**Amendments to the Drawings:**

## REMARKS/ARGUMENTS

Appl. No.: 09/998,676  
Amdt. Dated: October 31, 2005

Attorney Docket: NA01-002  
Reply to Office action of Sept. 26, 2005

FIG. 4

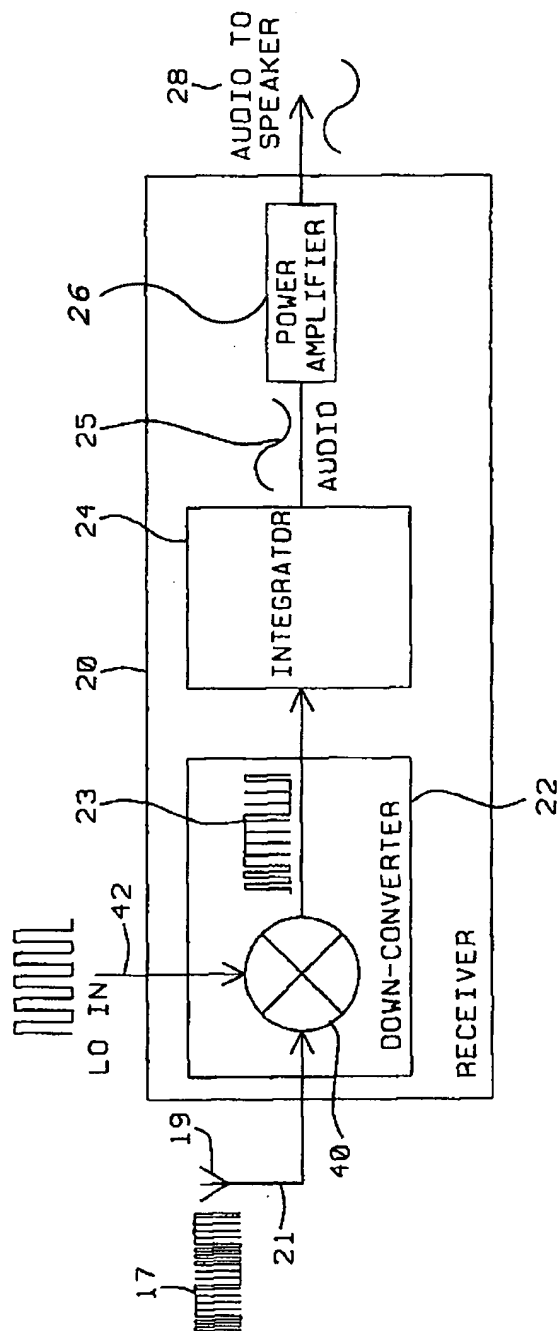
The attached sheet of drawings includes changes to Fig. 4. This sheet, which includes Fig. 4, replaces the original sheet including Fig. 4. In Fig. 4, the previously omitted reference character **26** of the element "**POWER AMPLIFIER**"

20 Fig. 4 has been modified with the changes marked in red on the attached drawings to add the previously omitted reference character **26** of the element

"POWER AMPLIFIER". Approval by Examiner Pham of these changes is requested. No new matter has been added.
